Re: North Campus Facilities

Subj: Change Proposal No. 233901-0011

Williamson County – North Campus Facility

ASI #08 – 4/10/2017

ITEM 1 – Steel bracing modifications and Elevator shaft modifications

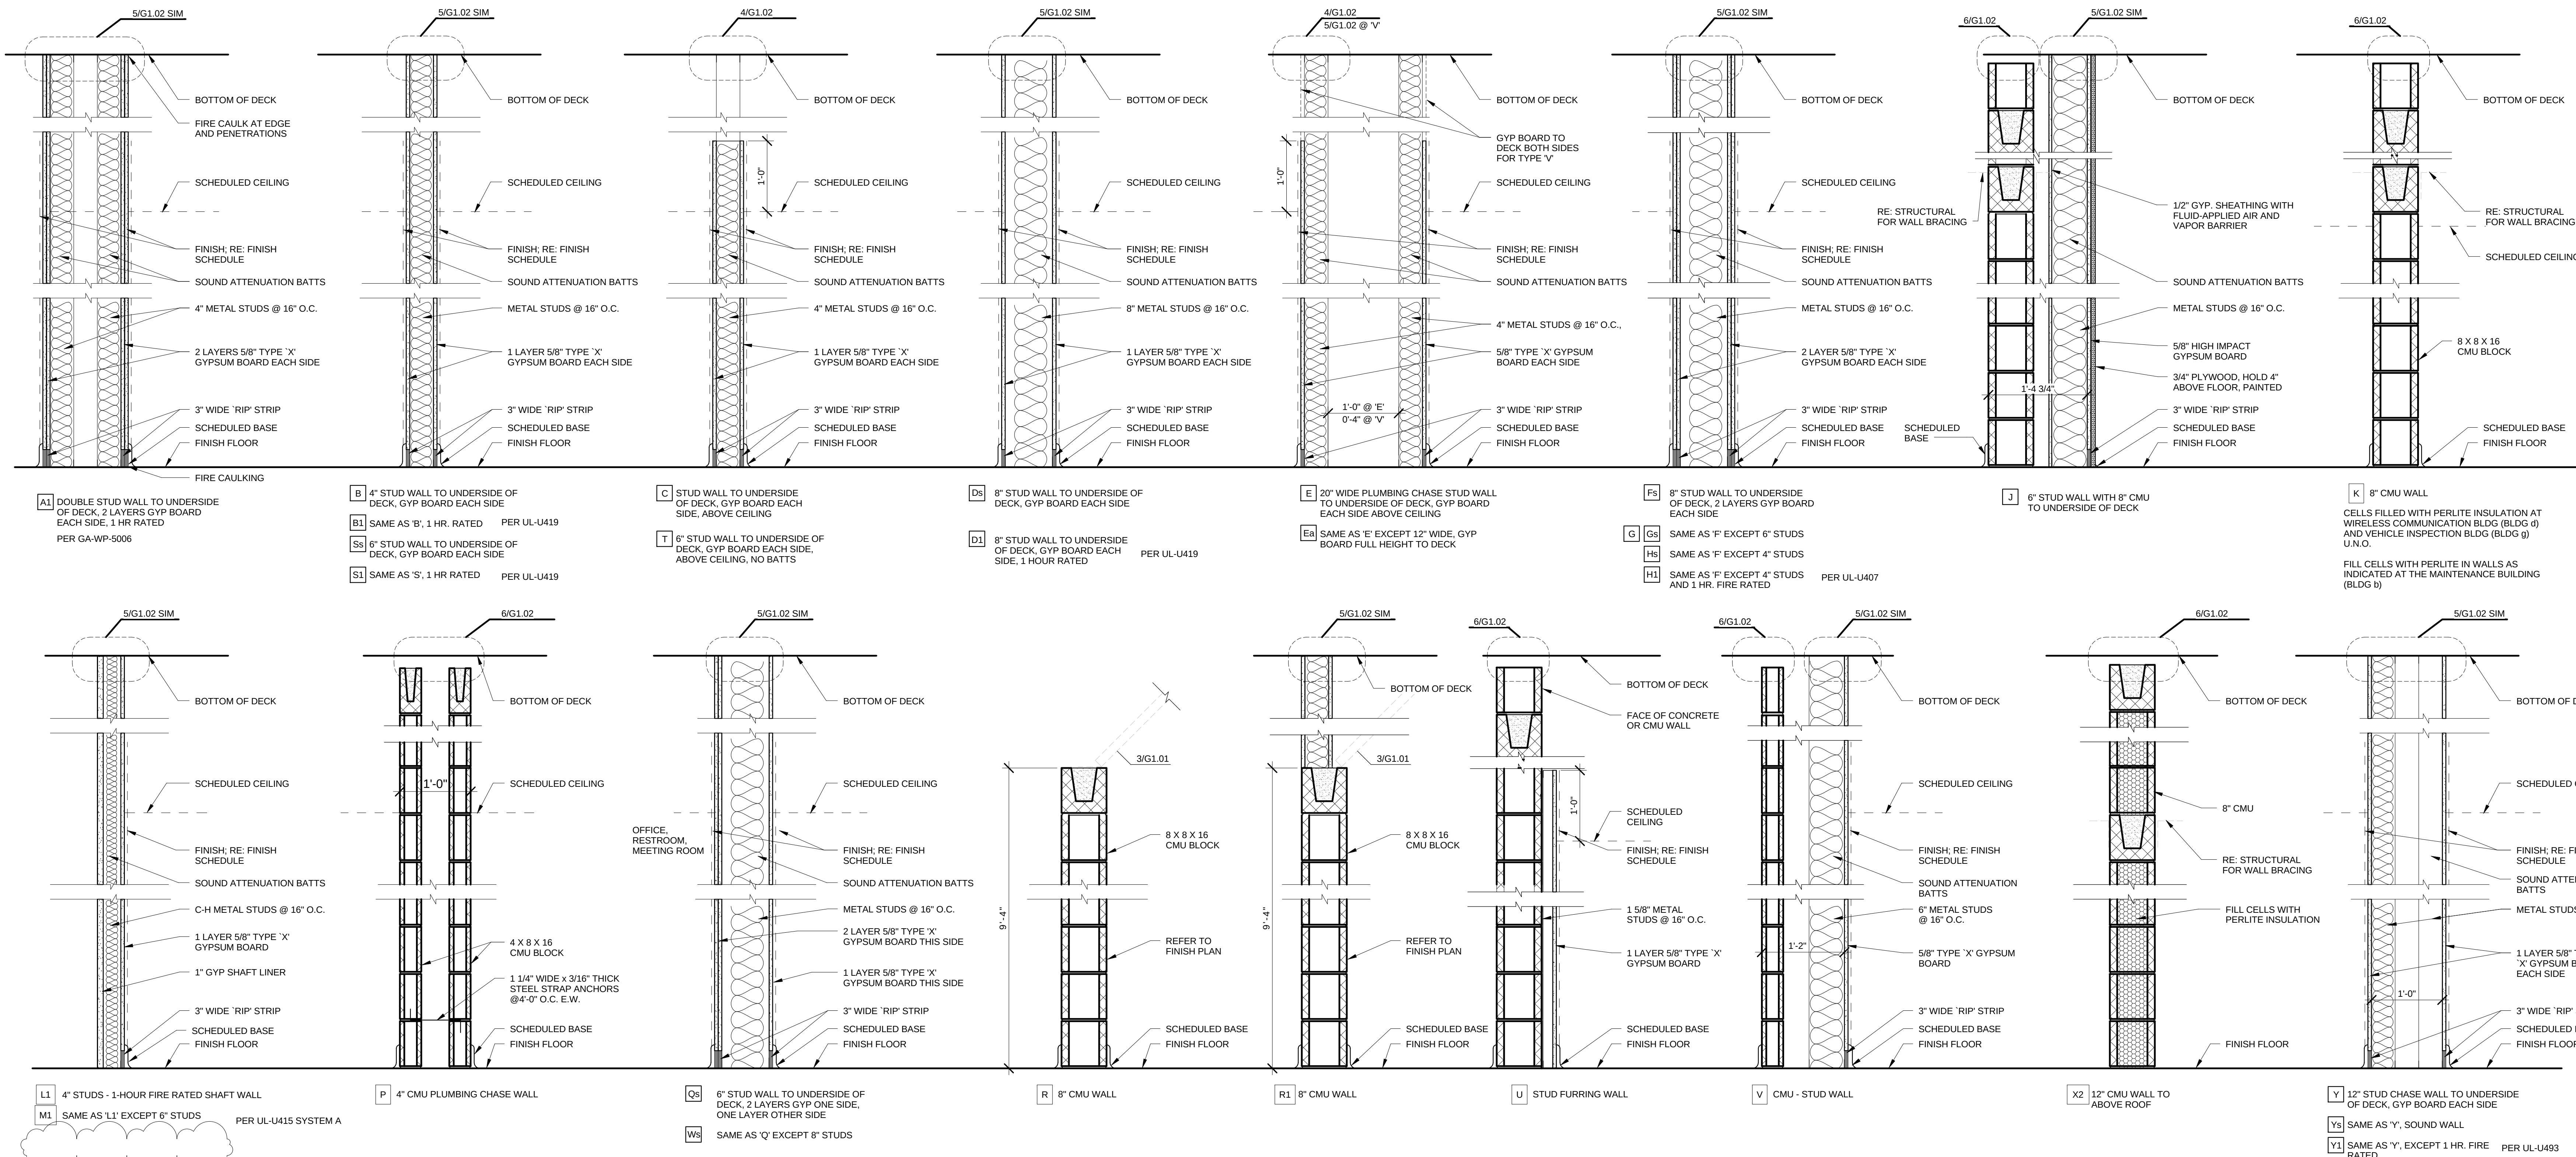
Steel bracing modifications, Elevator shaft modifications

See attached revised sheets G1.01, Ah2.01, Ah2.02, Ah3.01, Ah5.04, Ah7.02, Ah8.02, Ah9.01, Ah11.04, And sketches associated with the response to RFI # 69.

Drawing Number: Ah-7.02

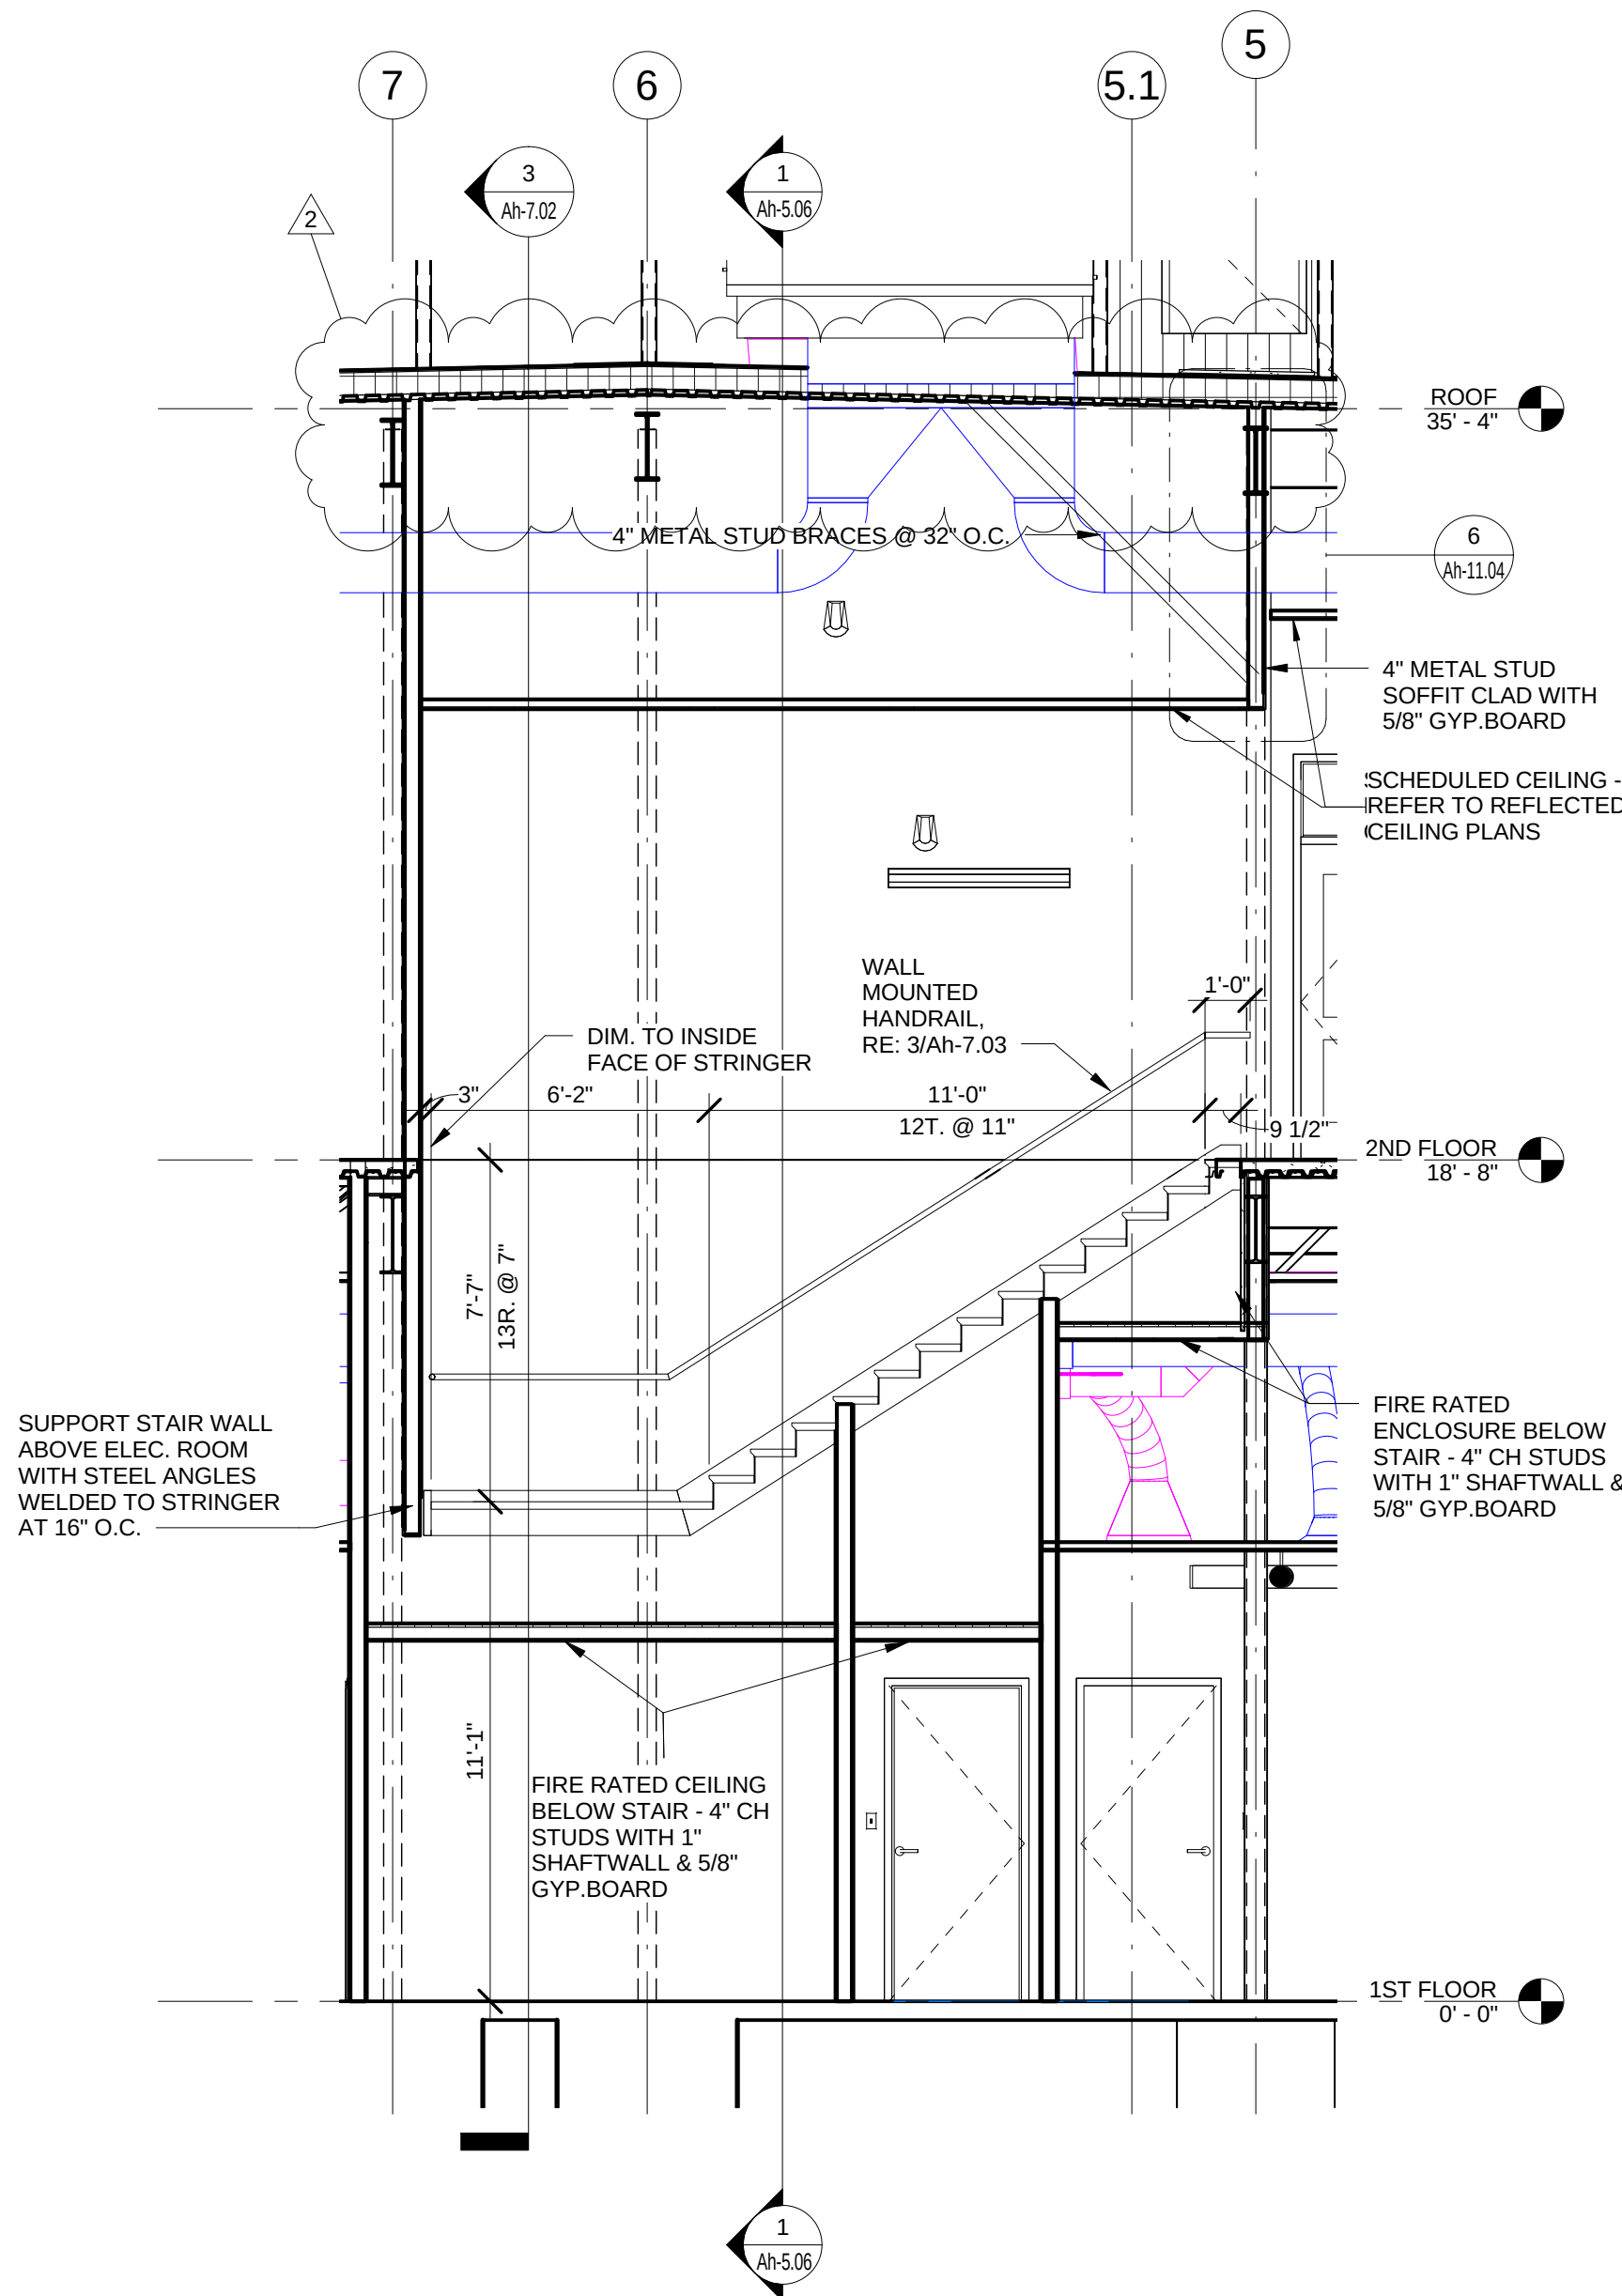
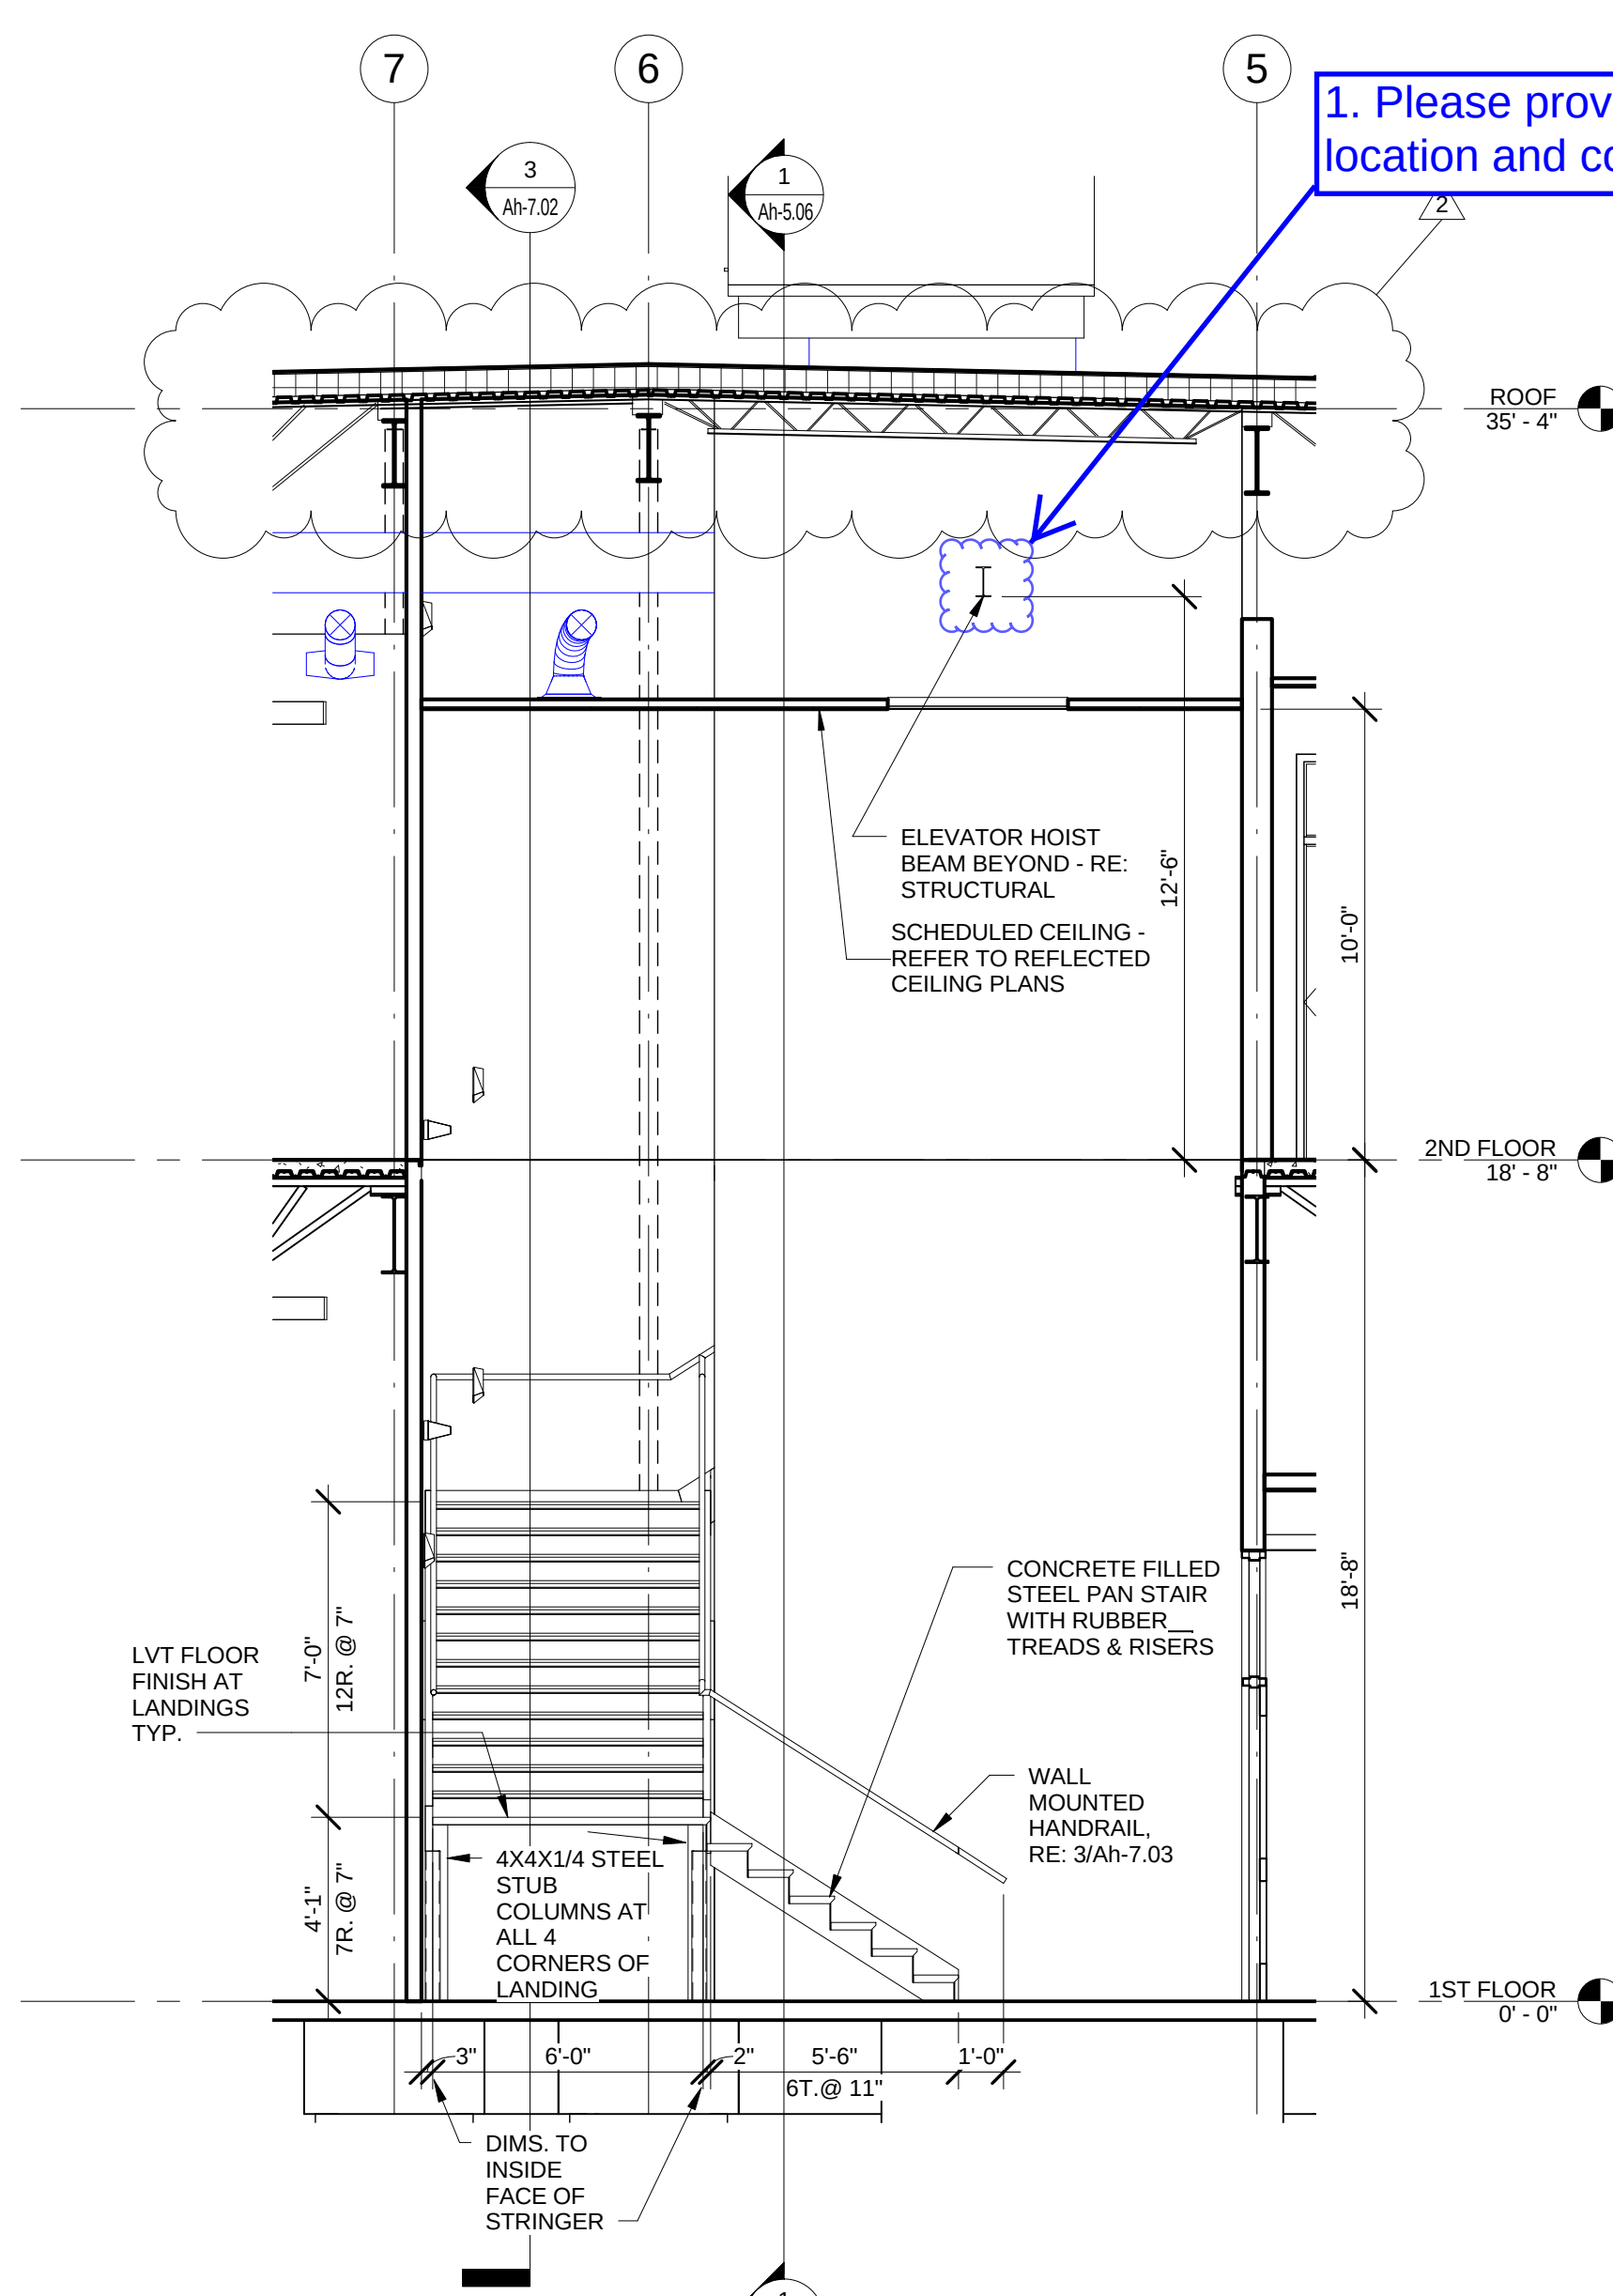
Please provide the hoist beam section size, location and connection details, as indicated in the attached sheet Ah-7.02.

Refer to attached details for structural steel posts and tube framing to support the hoist beam and to support the elevator guide rails as required by the elevator manufacturer.
